ADDENDUM
NO. 1

July 27, 2026

MERRILLVILLE HS CULINARY AND MEETING AREA RENOVATIONS AND MERRILLVILLE CSC CENTRAL OFFICE ADDITION AND RENOVATION PROJECT

This Addendum consists of pages ADD 1-1 through ADD 1-5 and attached and attached Addendum No. 1 from Gibraltar Design dated July 24, 2026, and consisting of 8 pages, revised Specification Section 08 71 00 - Door Hardware and 47 Drawings.

SHEET
T
T-121

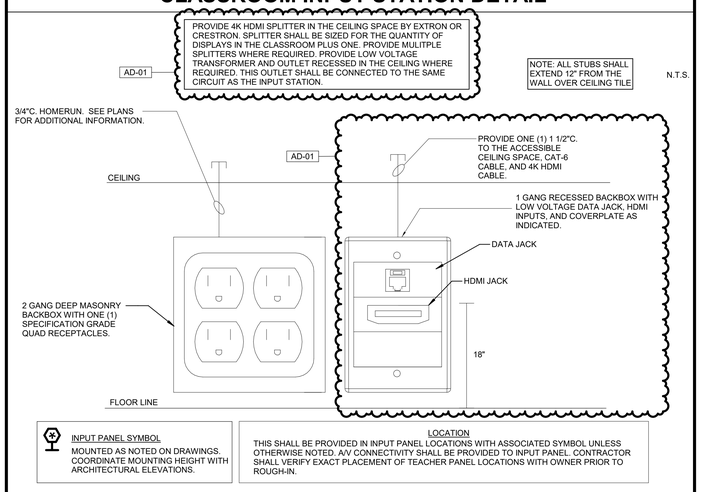
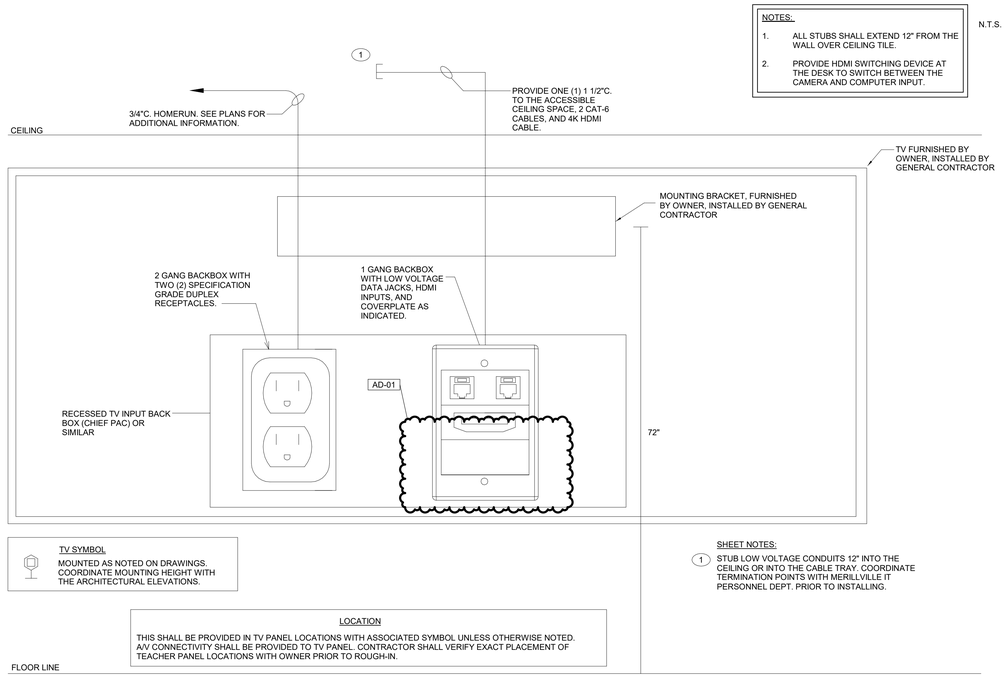
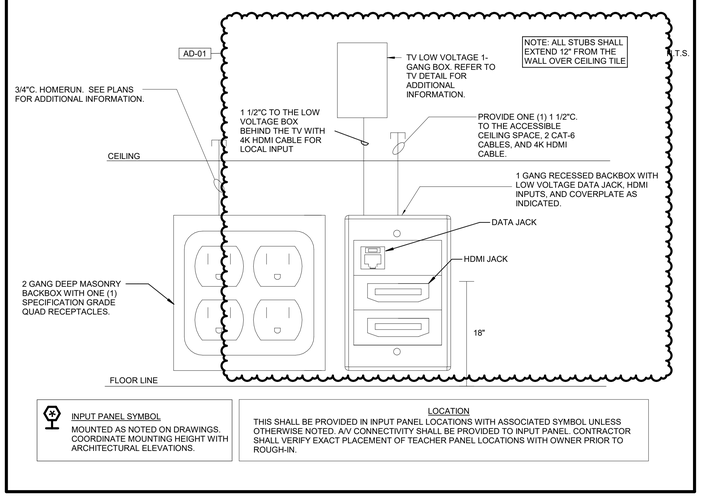
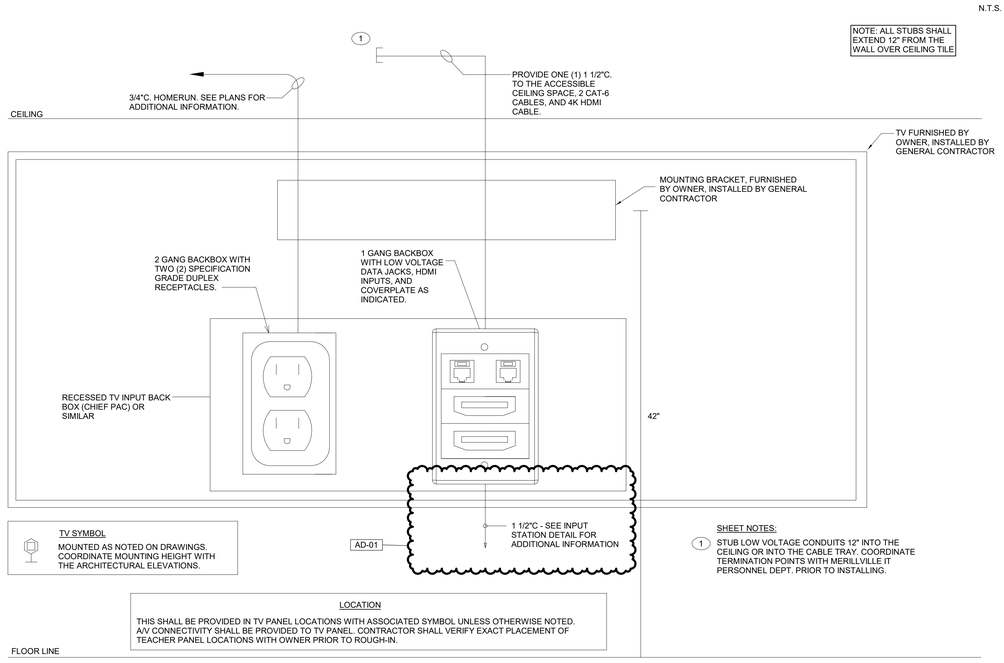
39. Sheet T-121

1. Added technology devices and notes
2. Revised technology device locations
3. Added camera connections.
4. Added matrix touch screen controllers.

1 A-101 **ARCHITECTURAL FIRST FLOOR PLAN**

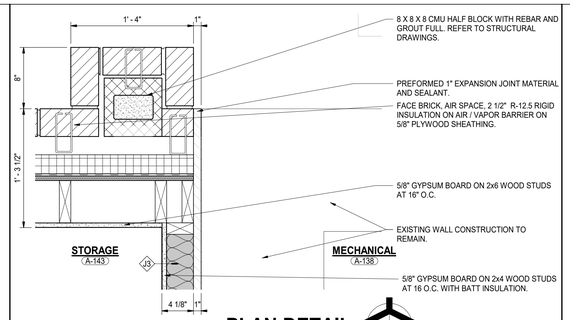
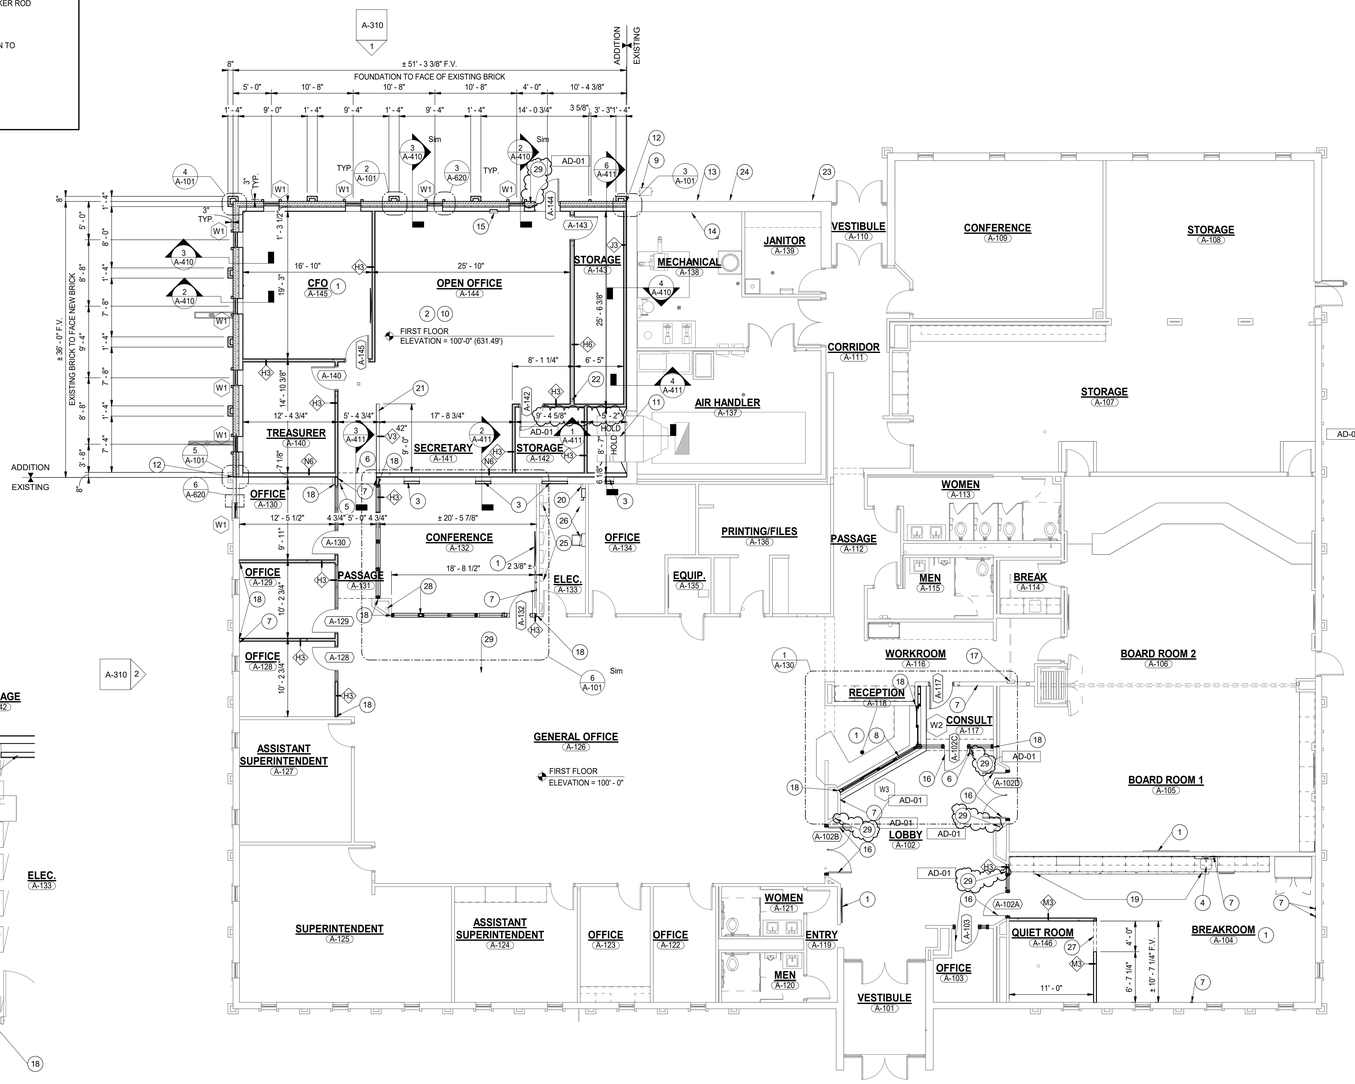
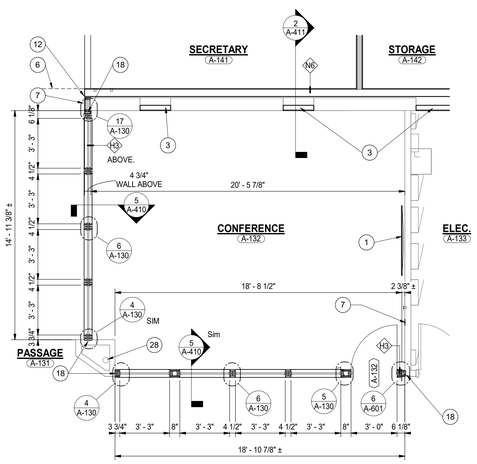
43. Sheet A-101

1. Revised plan note 28.
2. Added plan note 29 to plan notes and floor plan.
3. Revised dimension of Storage A-142.

DRAWING
DOOR SCHEDULE, FRAME PROFILES, ELEVATIONS AND DETAILS

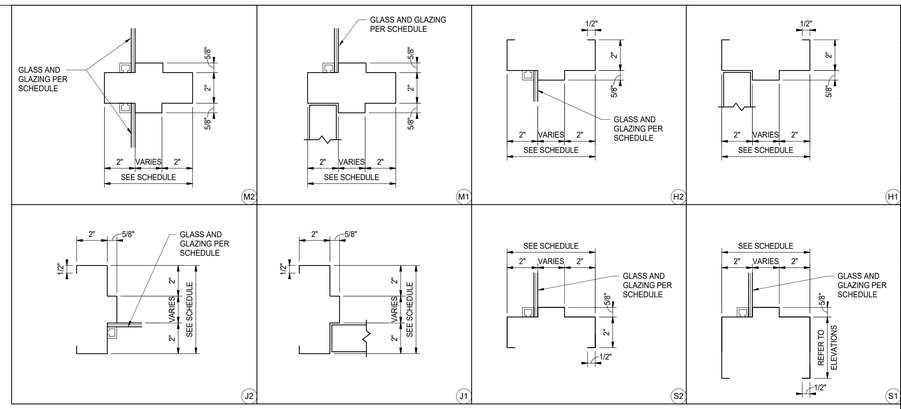
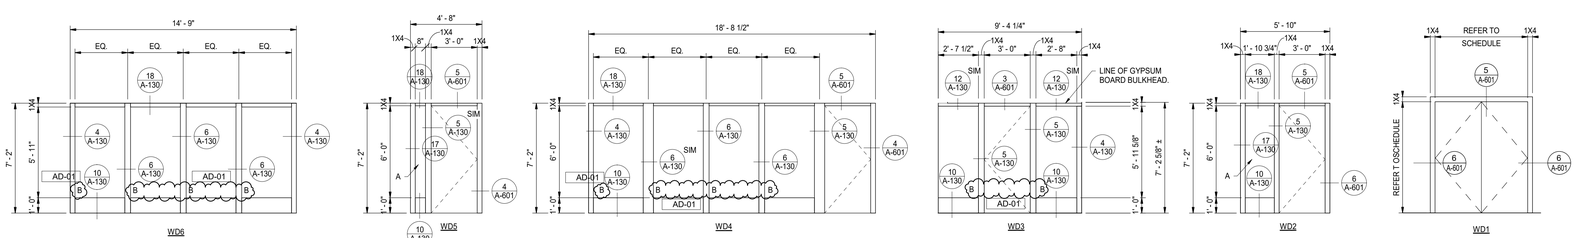
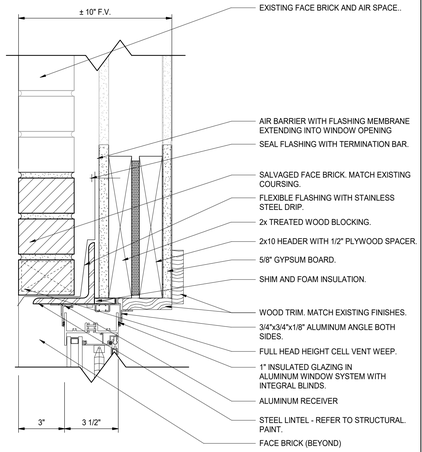
45. Sheet A-601

1. Revised glass type for wood frame elevations WD3, WD4, and WD6.

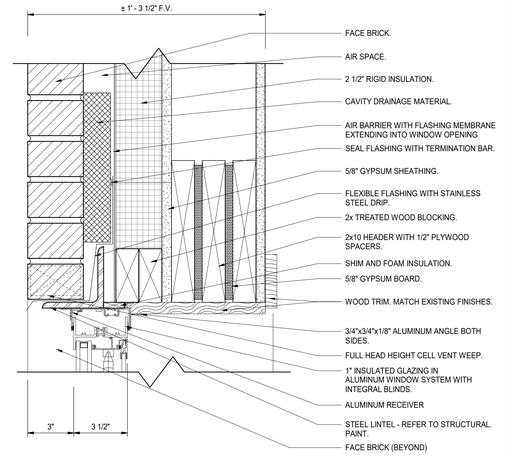
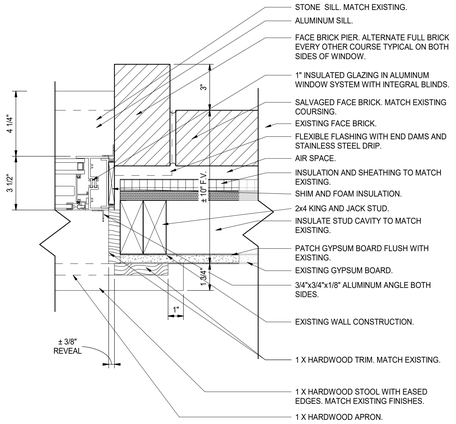
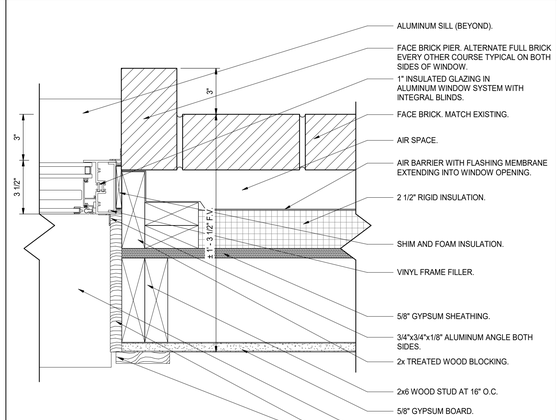
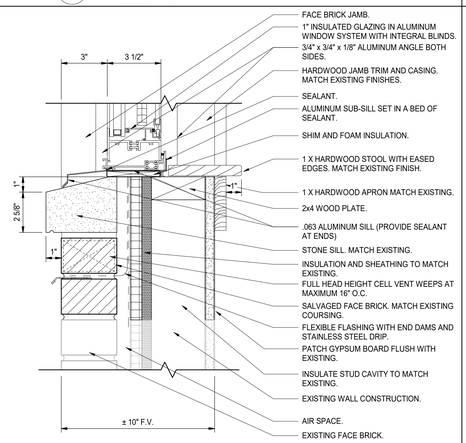
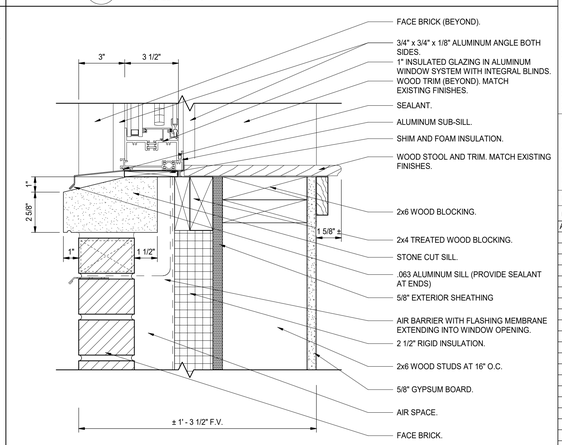
46. Sheet A-620

A. Refer to revised, full-size drawing, included in this Addendum, for revisions.
   1. Add callouts to Window Elevation 1/A-620 and Wood Window Elevations10/A-620.

SHEET
A-901

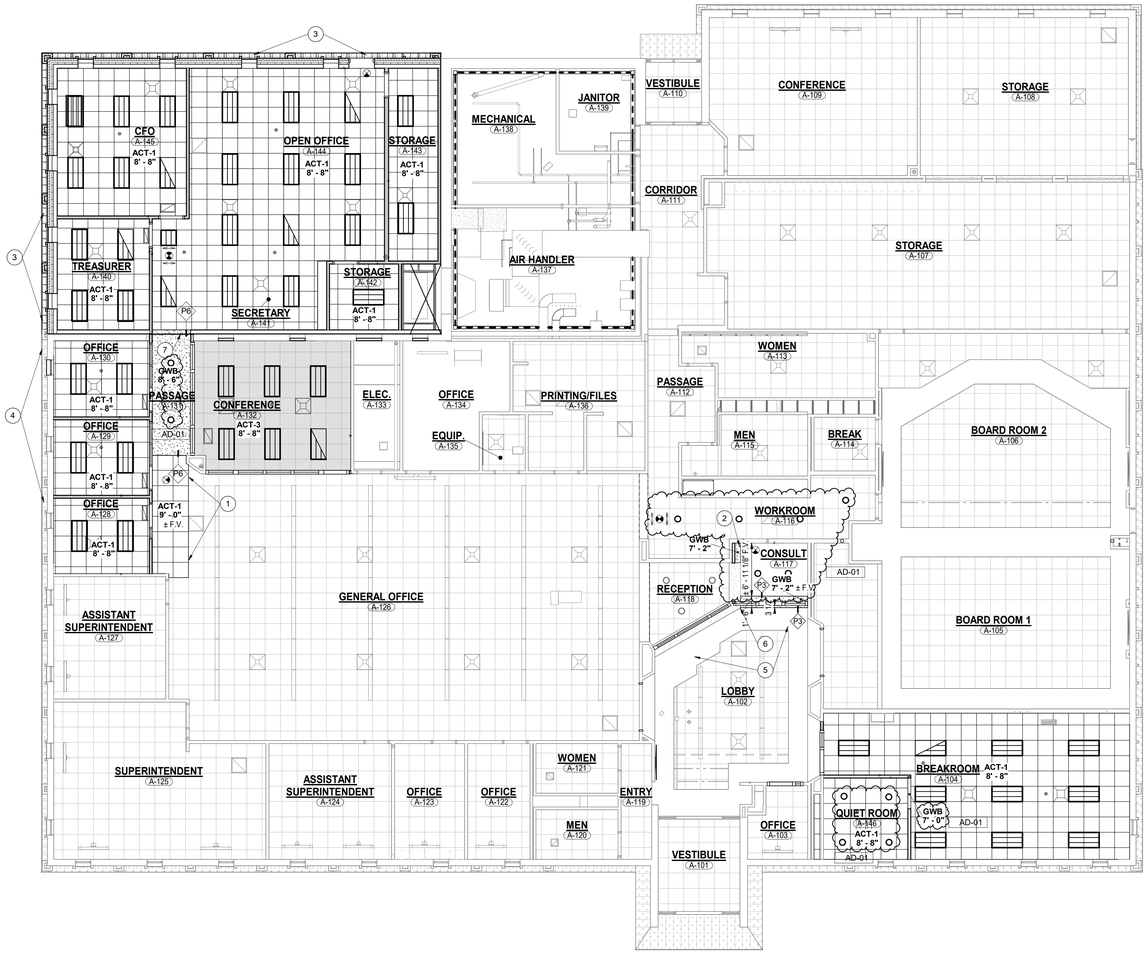
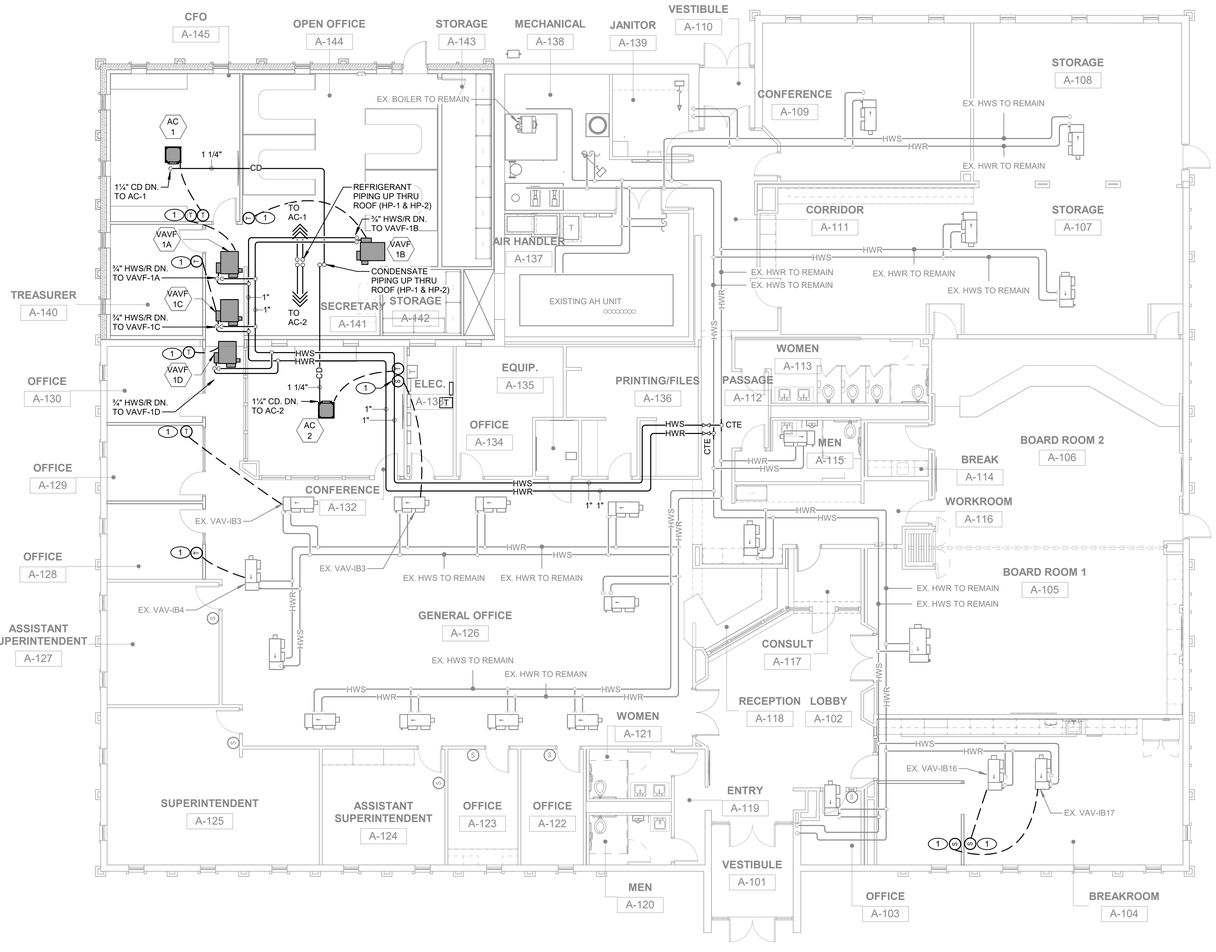
47. Sheet A-901

A. Refer to revised, full-size drawing, included in this Addendum, for revisions.
   1. Updated plan to show missing light fixtures.

SHEET
T-002

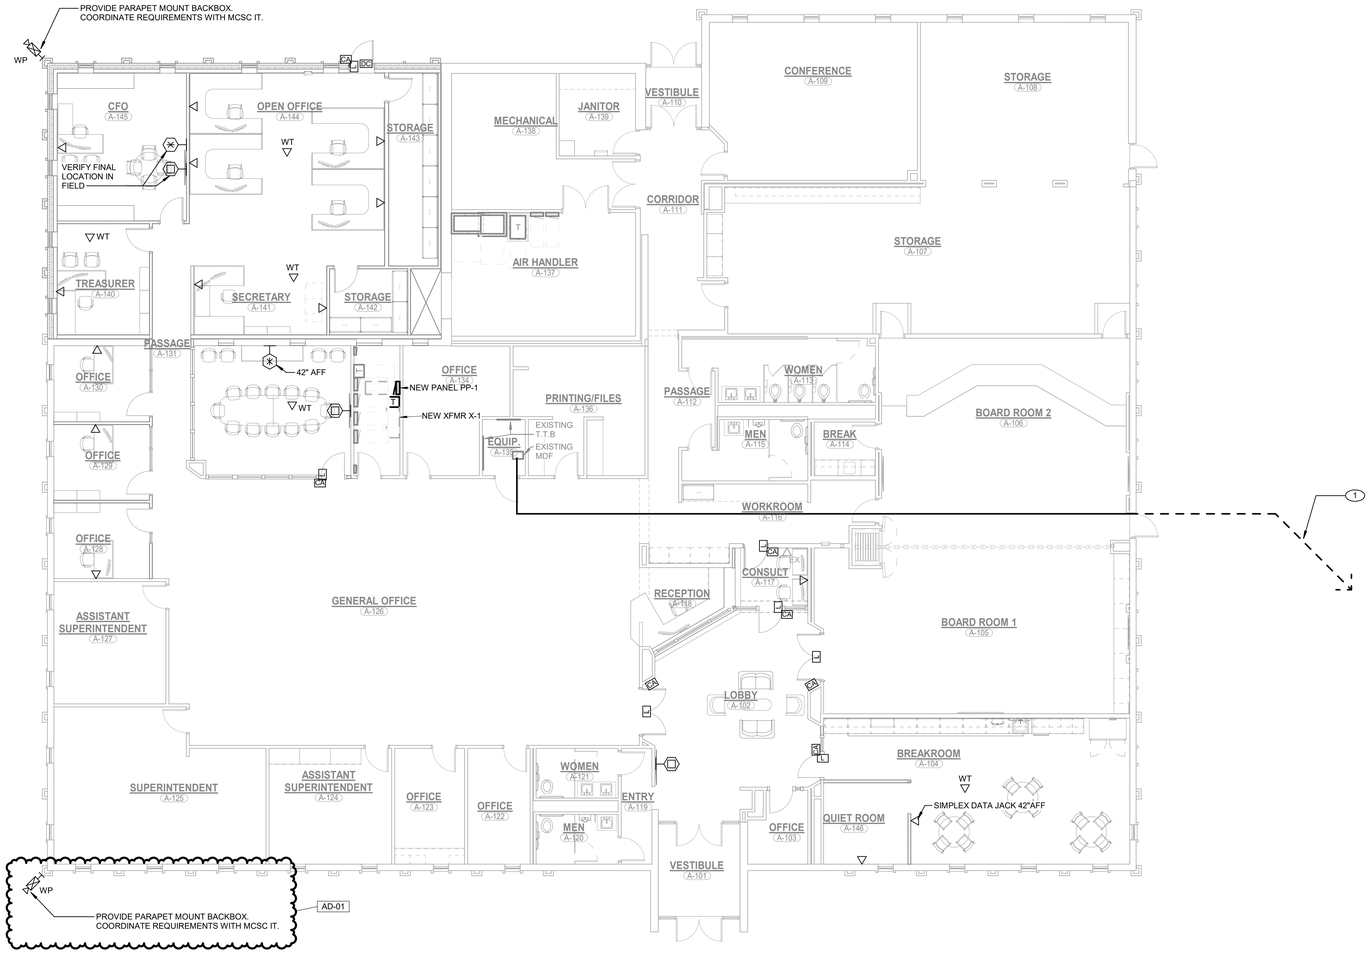
54. Sheet T-002

A. Refer to revised, full-size drawing, included in this Addendum, for revisions.
   1. Updated access control wiring diagram
